VV support and diagnostic port interference

Port location after rotating port

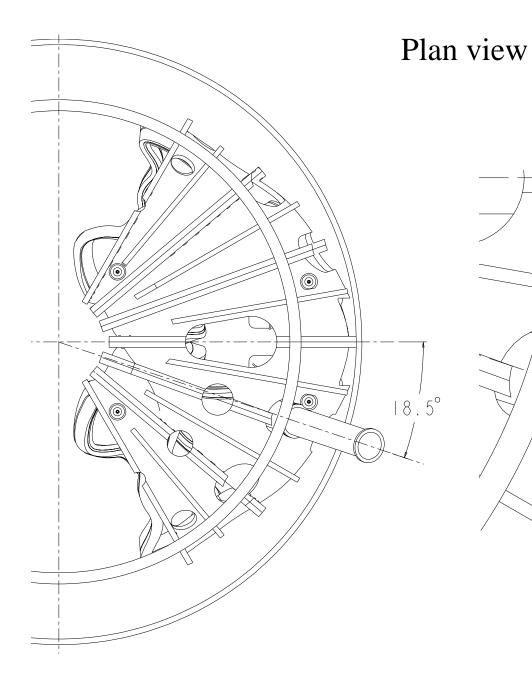
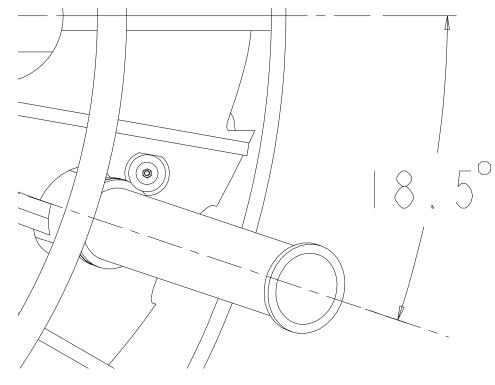
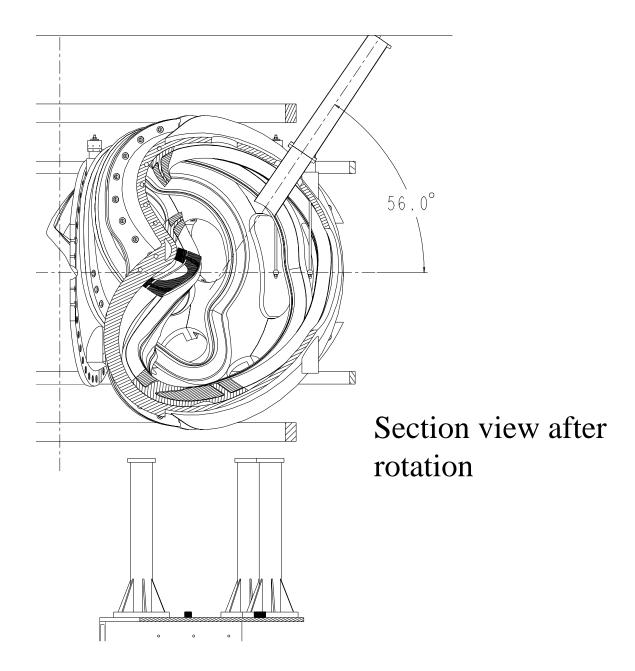
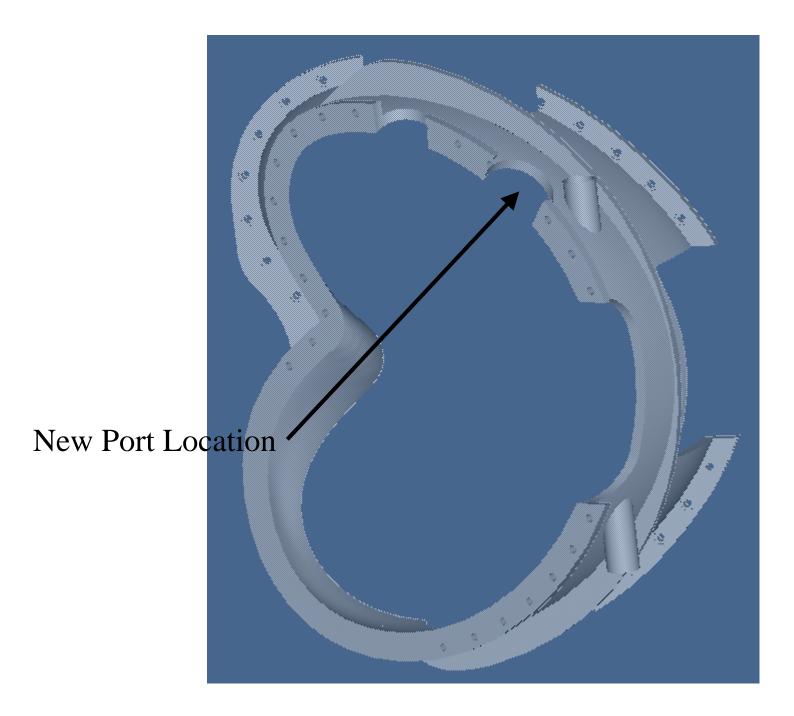
Location Before:

Torordial angle 17 deg Poloidal angle 47 deg

Location after rotation

Torordial angle 18.5 deg Poloidal angle 56 deg

Port dia 10" od before and after

From Tom Brown's Power Point file

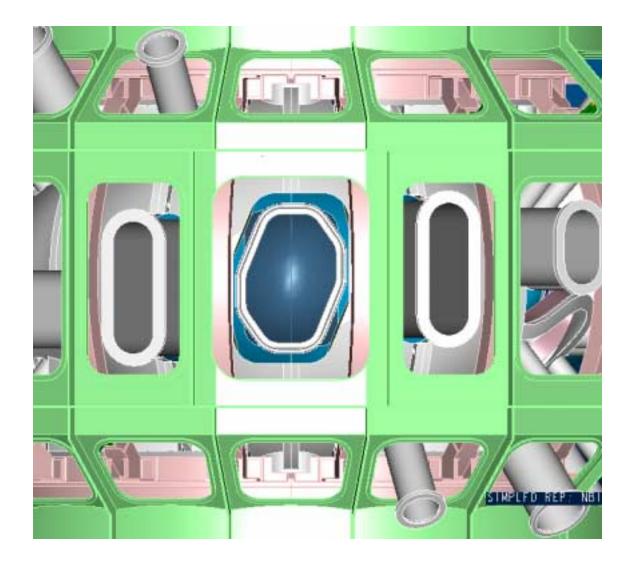
The modular coil shell opening and NBI port were reshaped to eliminate port interference with modular coils.

View looking down on the machine

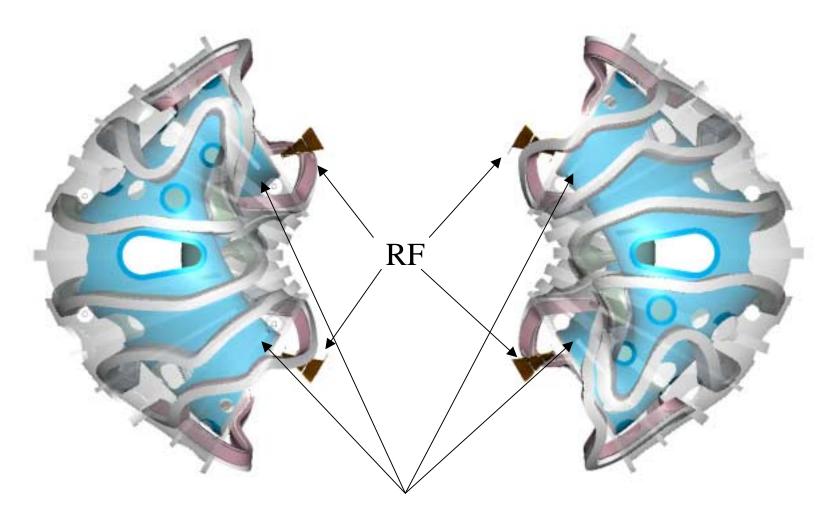
? Coax Feed locations?
